**Delmarva Christian School
21777 Sussex Pines Road, Georgetown, Delaware
Bid Pac A– Contracts 1 thru 18
April 28, 2025**

Addendum No. 2

Addendum No. 2 consists of:
RYJ Written directive (3 pages)
Drawing Sketch G104 (1 Drawing)

G104
DO NOT SCALE DRAWING

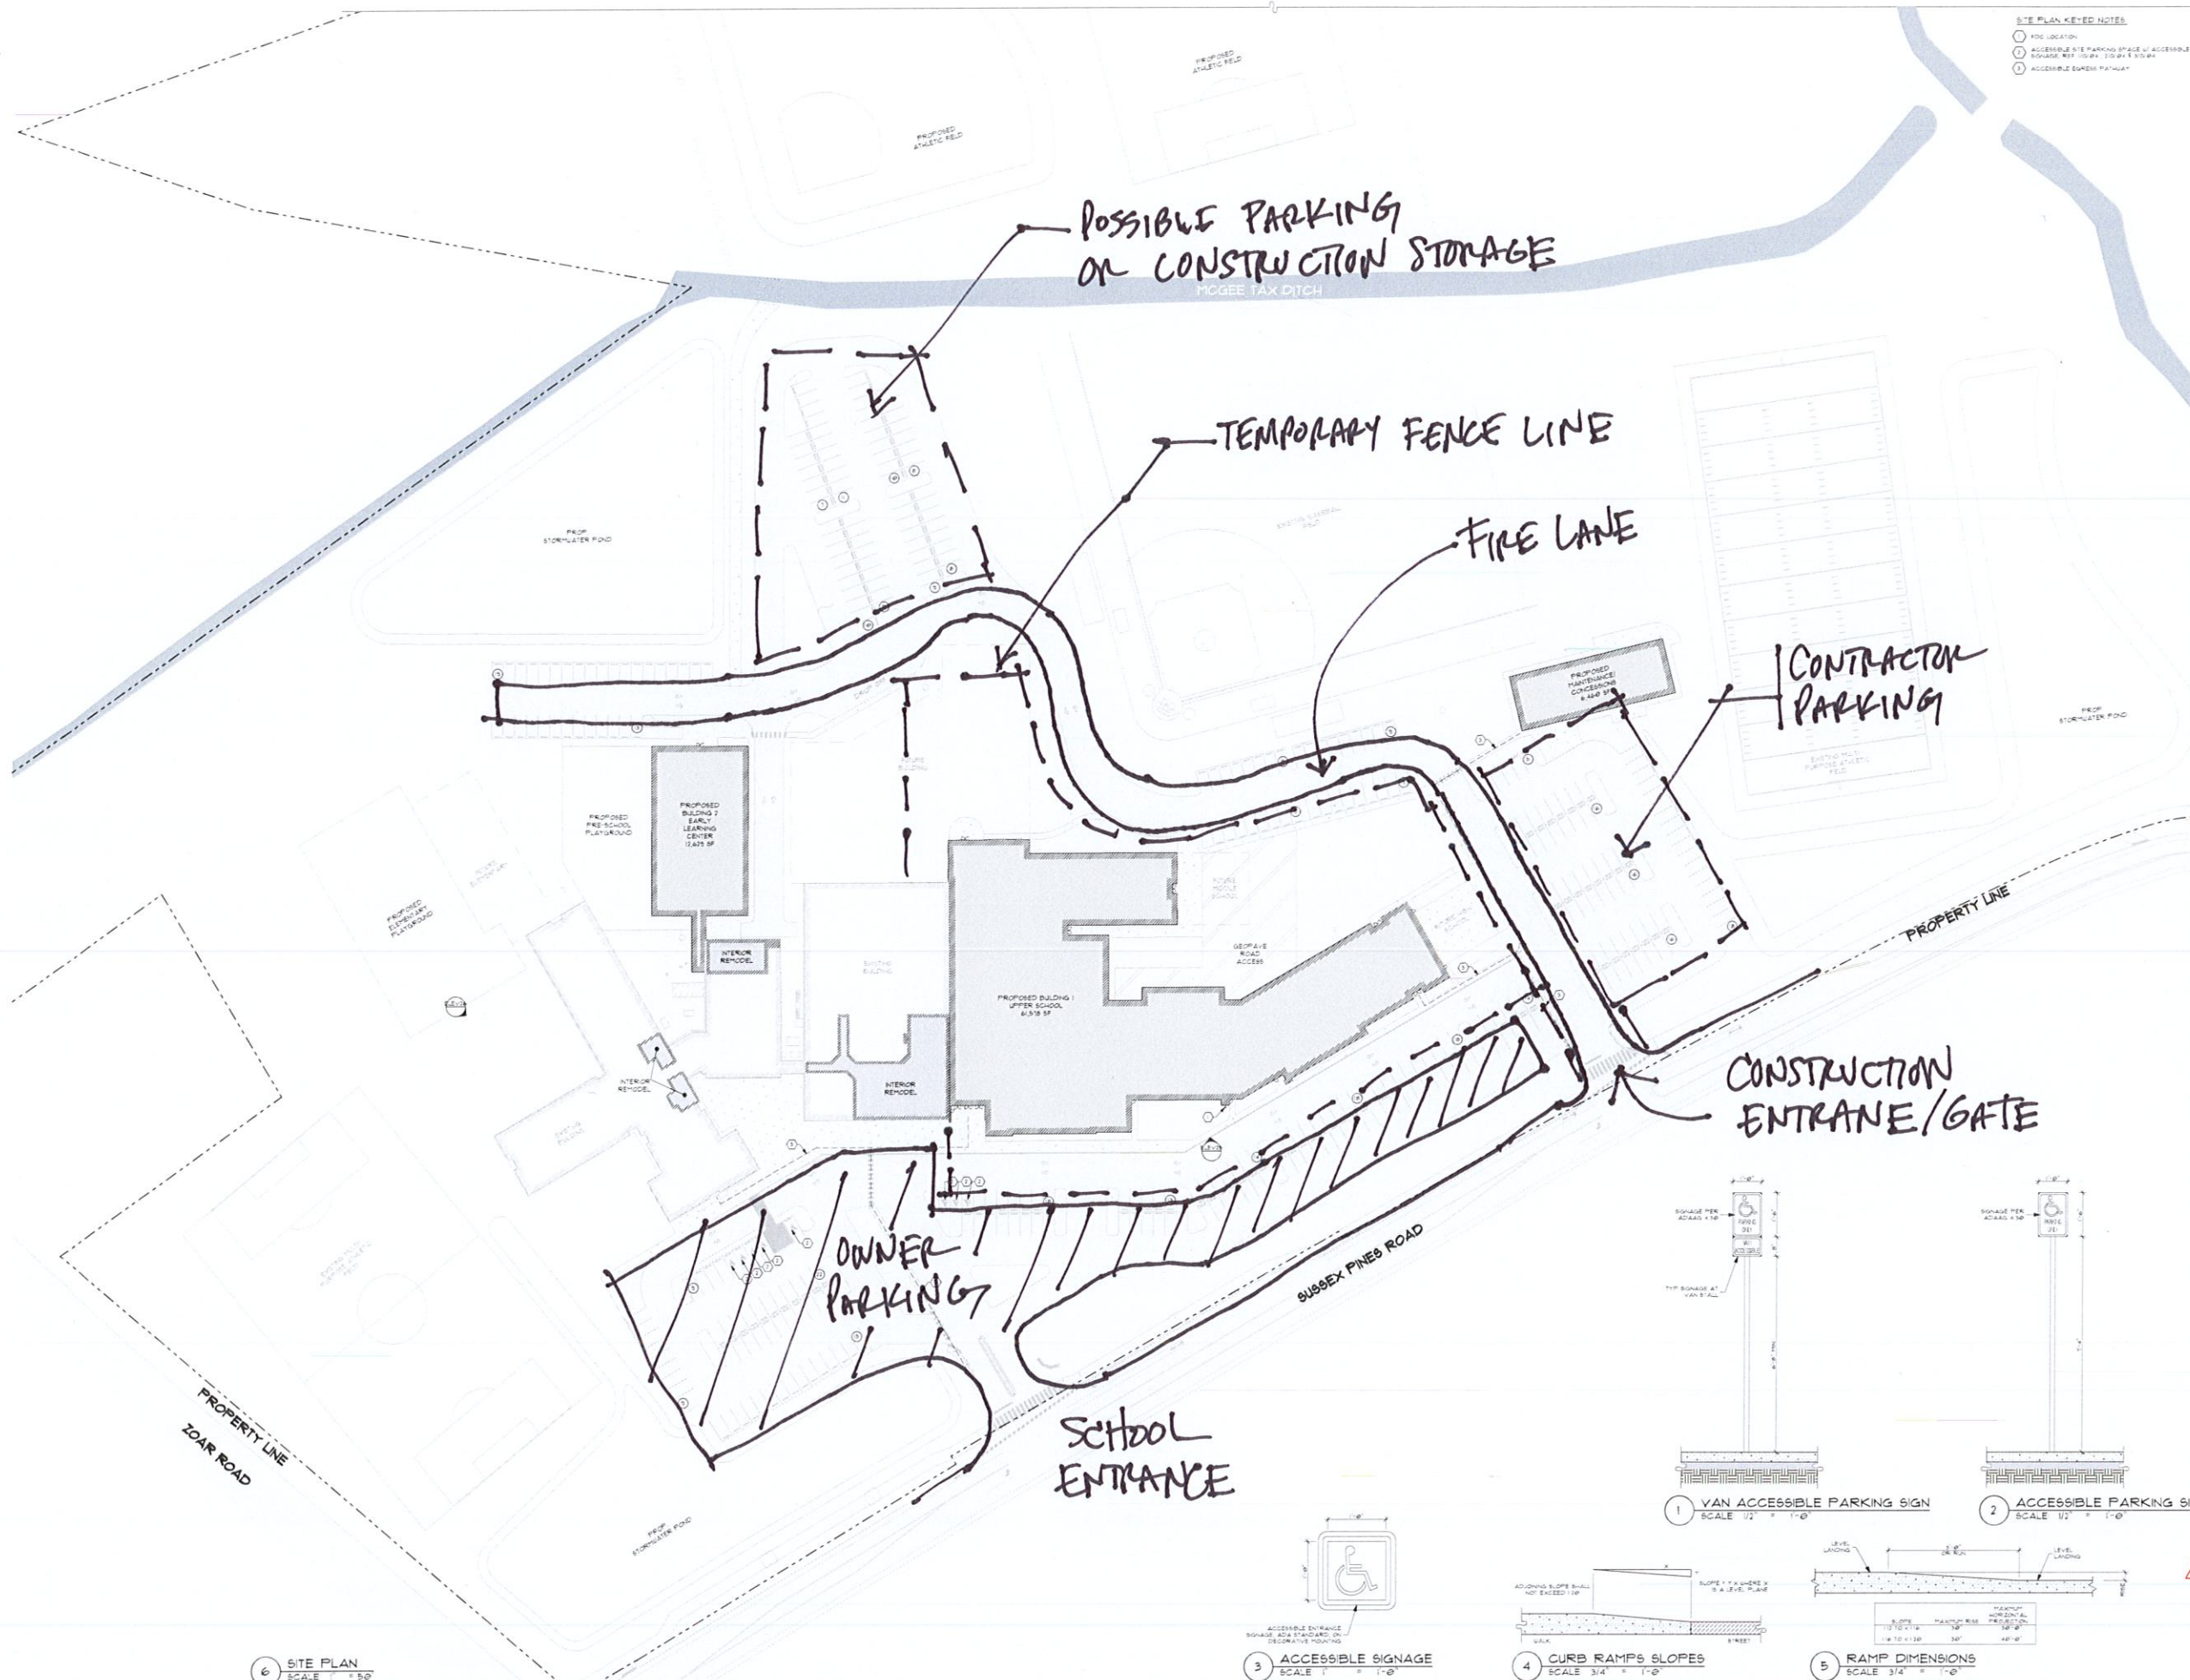
Page 011100-9; Add Paragraph PPP “PPP. This contract is required to have the owner parking area stoned and base paved along with the fire lane prior August 15, 2025; reference Drawing G104 in Addendum 2 for clarification.”
